**P23-09**  
**Premier Bank Drive Through**

Property Owner: Premier Bank  
Applicant: Brian Midock  
Location: 830 North Court Street  
Zoning: C-3 (General Commercial)  
Request: Site Plan and Conditional Zoning Certificate approval for a bank drive through expansion

1 SITE PLAN - NEW  
 SCALE: 1" = 10'-0"

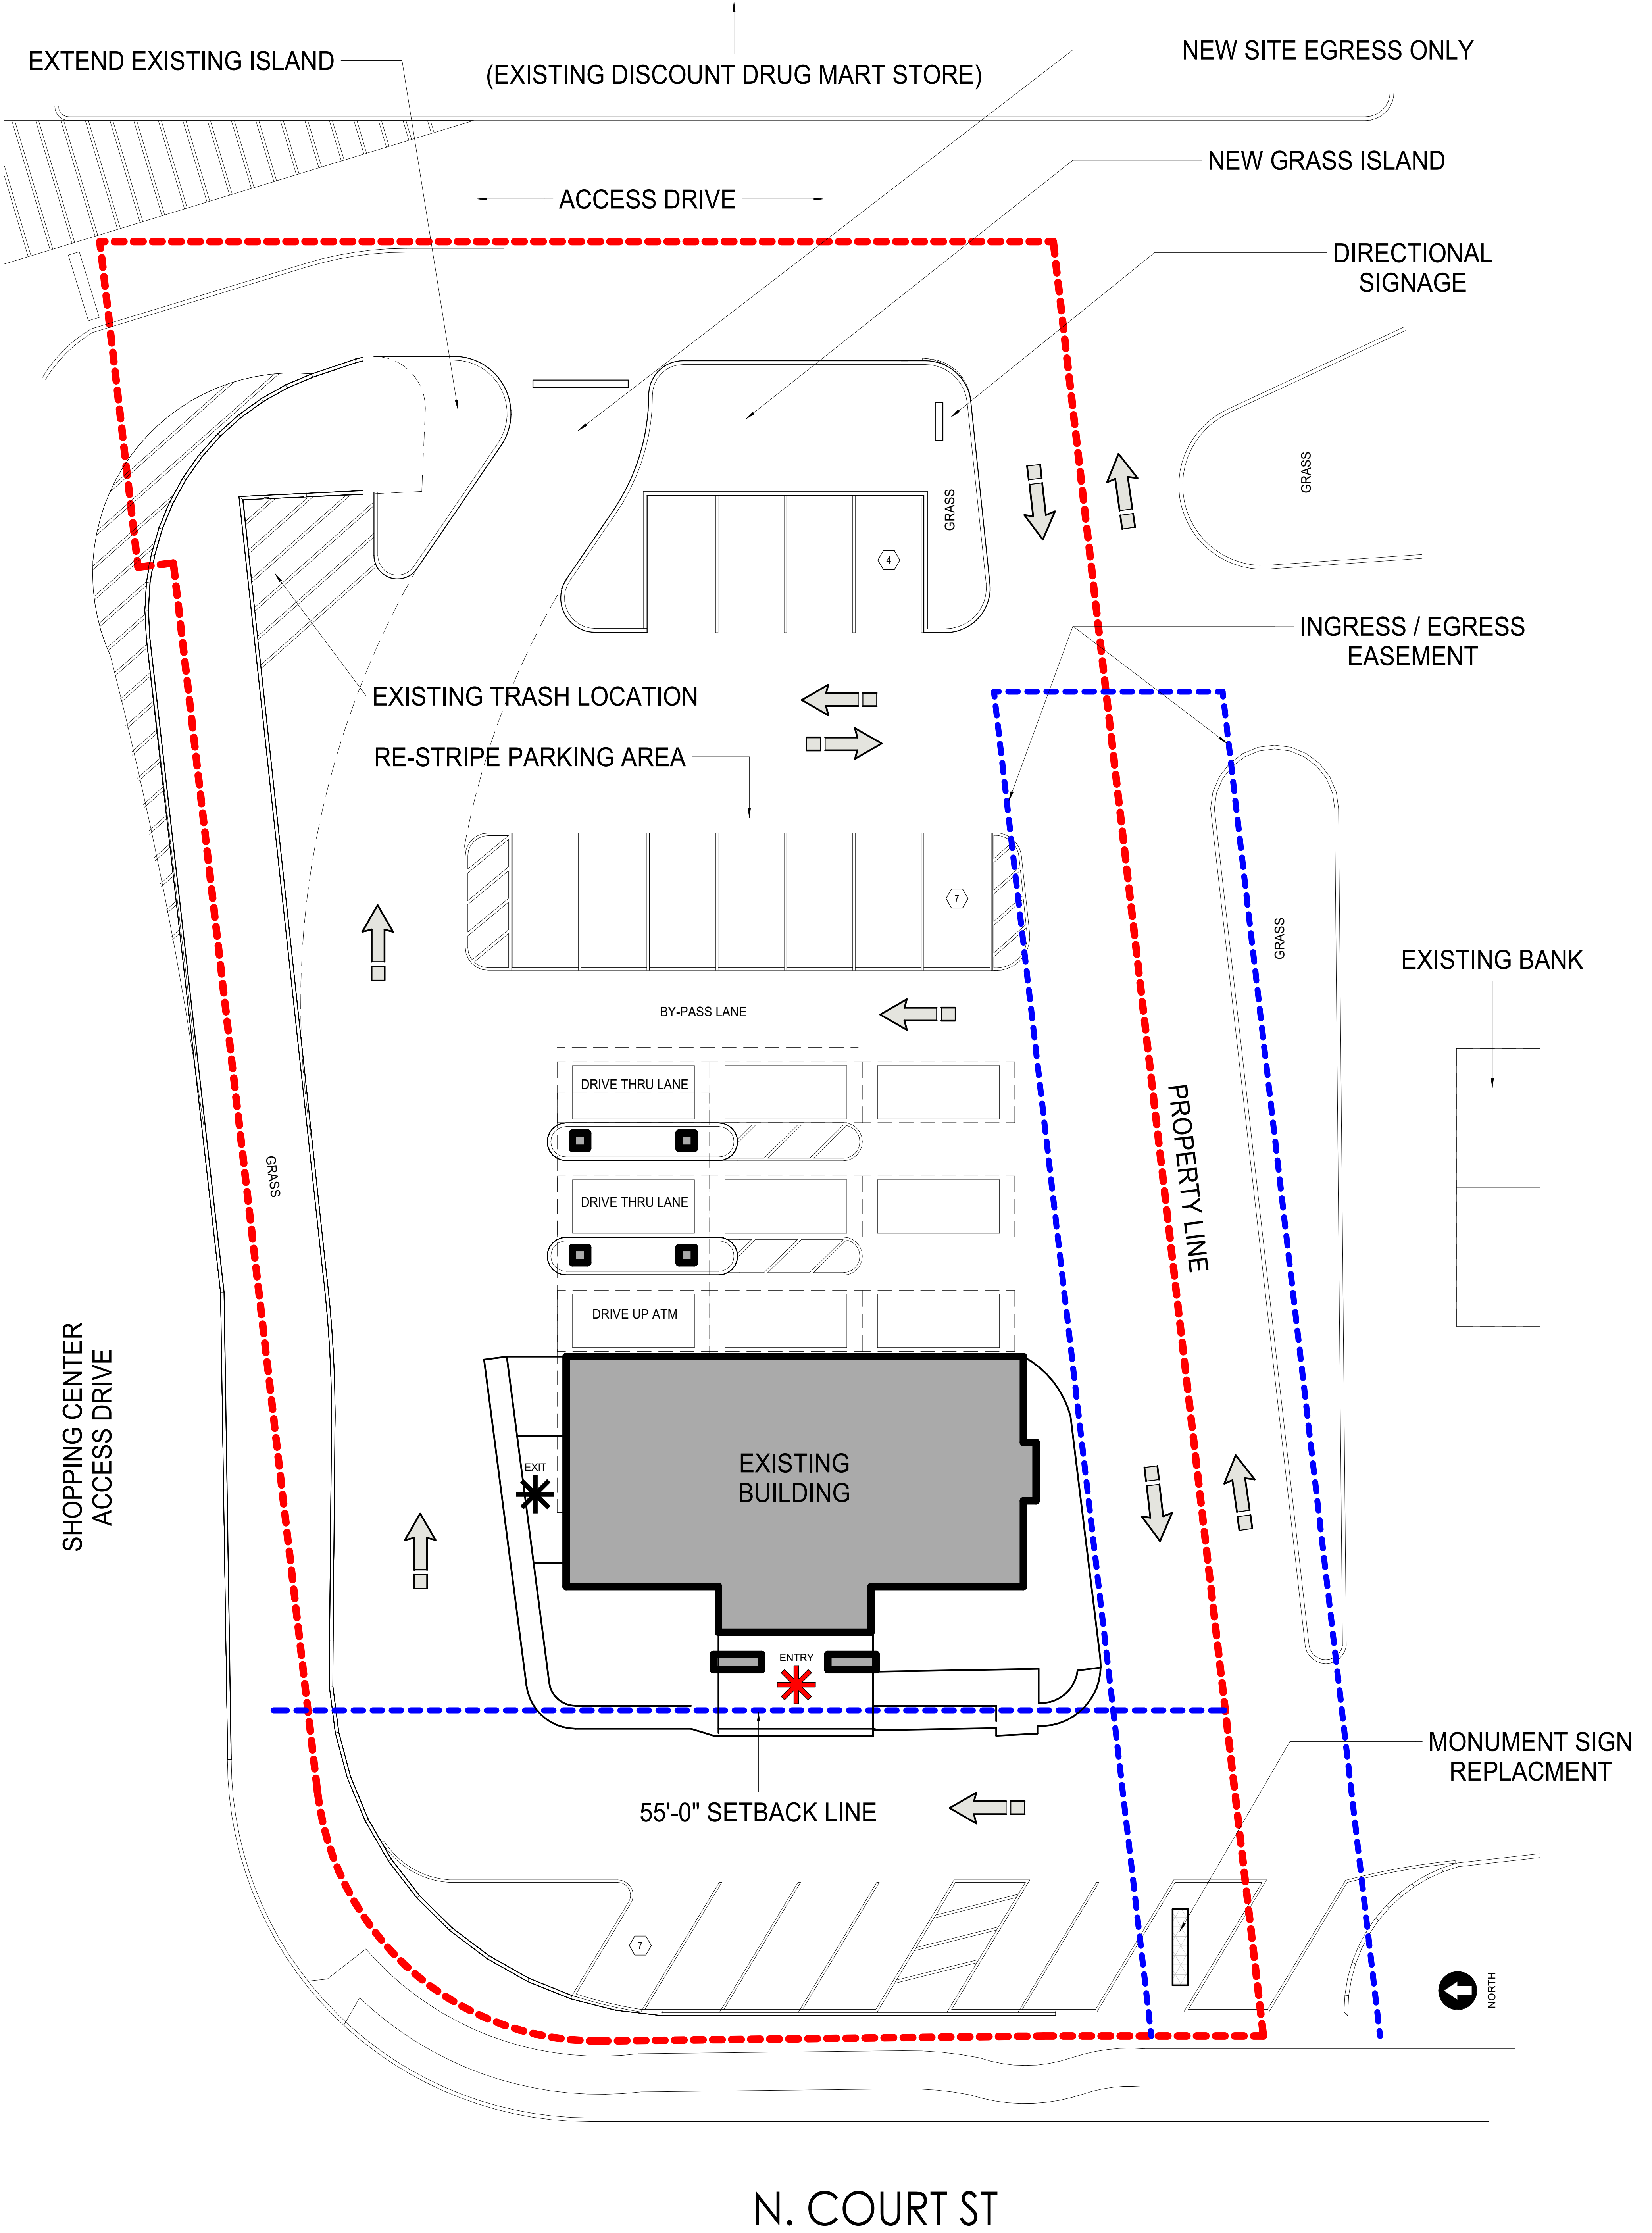
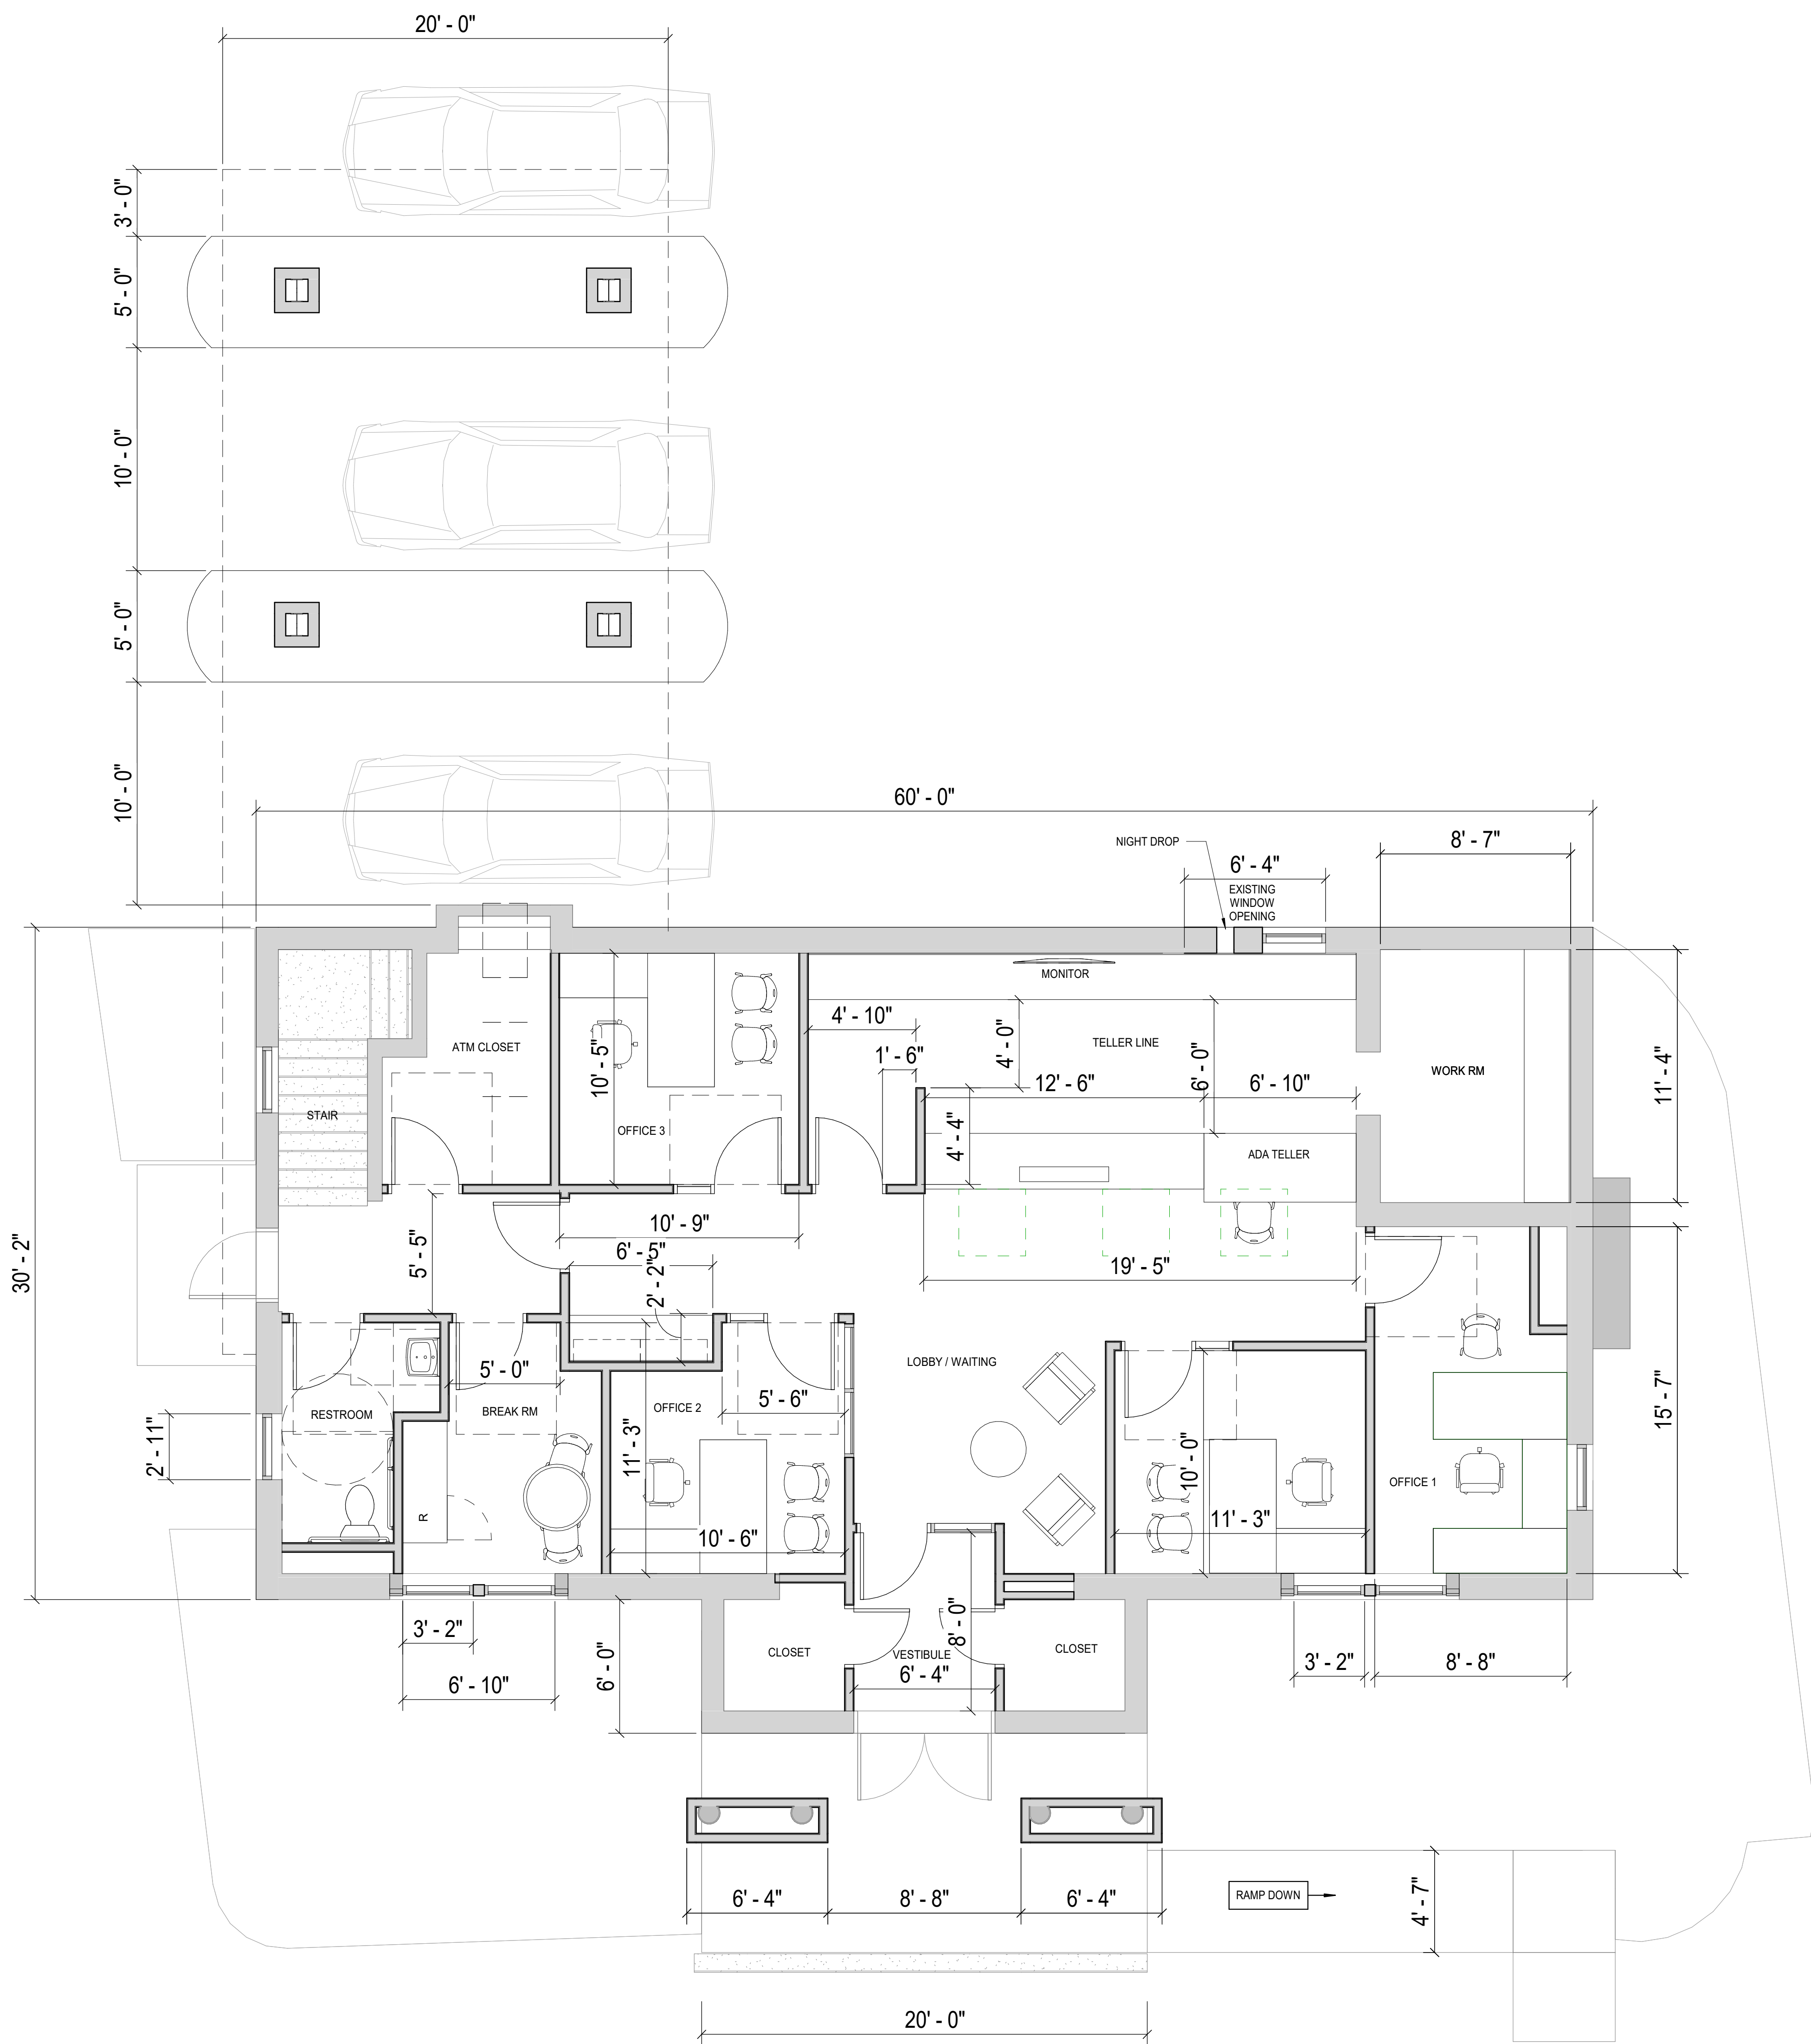
Section 1145.04(a) includes a table which states that banks must have 4 stacking spaces for drive through lanes. The applicant has indicated three total drive through lanes on the east side (rear) of the building, which will be covered by a proposed canopy. Each drive through lane will have 3 stacking spaces, which is less than required by Section 1145.04(a).

An existing partial ingress/easement is indicated on plans. The Engineering Department has noted that the easement should be extended to allow the property full access.

Parking Dimensional Standards – New parking spaces to the rear of the building are 9 ft. x 18 ft. with a 26 ft. aisle. Per Section 1145.08, parking will need to be reconfigured to be the required 9 ft. x 19 ft. with a 24 ft. aisle.

Parking Lot Landscaping – New grass islands have been created on the east side of the site. The landscape islands must incorporate landscape materials such as trees, bushes, and/or shrubs per Section 1145.09(b).

Trash Enclosure – An existing trash container is indicated in the northeast corner of the site, however, the location does not contain a trash container. A trash container cannot be situated at the indicated location as a stormwater inlet structure is present and it is within the required setback.

A trash container must include an enclosure and meet the applicable setback for accessory structures (20 ft.).

1. Access easements shall be modified or created as required by the City Engineer.
2. Parking spaces to the rear of the building shall be adjusted to comply with dimensional requirements of Section 1145.08 and parking lot islands on the east side of the site shall incorporate landscape materials such as trees, bushes, and/or shrubs per Section 1145.09(b).
3. Trash containers shall comply with screening and setback requirements of Section 1155.05 and shall not conflict with stormwater structures.
4. Consider reworking the main entrance feature on the front of the building to complement the existing pitched roof building.
5. The project shall comply with Planning and Zoning Code Section 1145.04(a) regarding drive through stacking spaces or a variance shall be approved by the Board of Zoning Appeals.
